New Albany Planning Commission
Wednesday, January 21, 2026 Meeting Minutes - Approved

ZC-80-2025 Fire Station Rezoning

**Planning Commission Staff Report
January 21, 2026 Meeting**

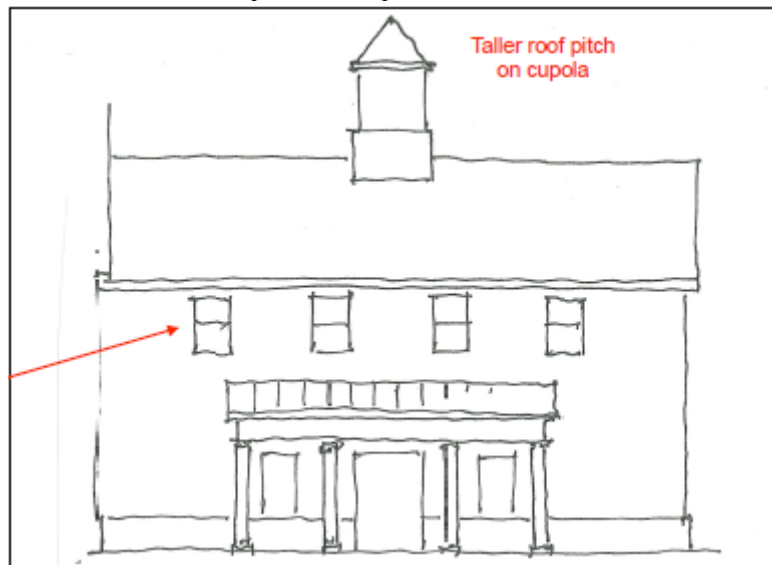
7. The existing zoning text requires a minimum pavement and building setback of 125' which the proposed development is exceeding.

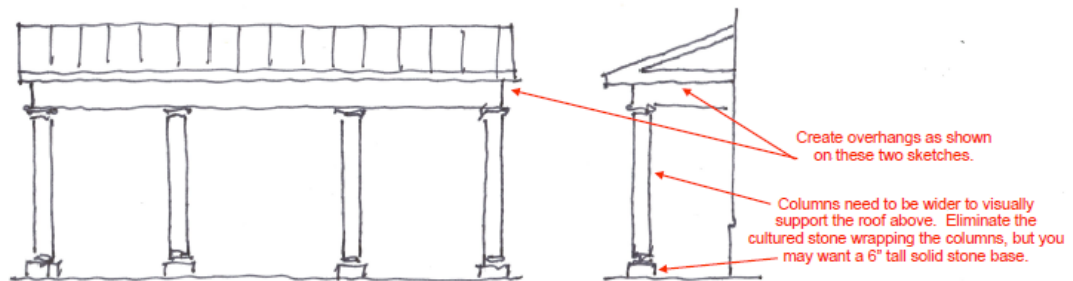
- Provide a taller roof pitch on cupola.

- Create overhangs as shown on the sketch below

- Columns should be wide to visually support the roof above. Eliminate cultured stone wrapping the columns and use a 6' tall solid stone base.
- Align neck of columns.
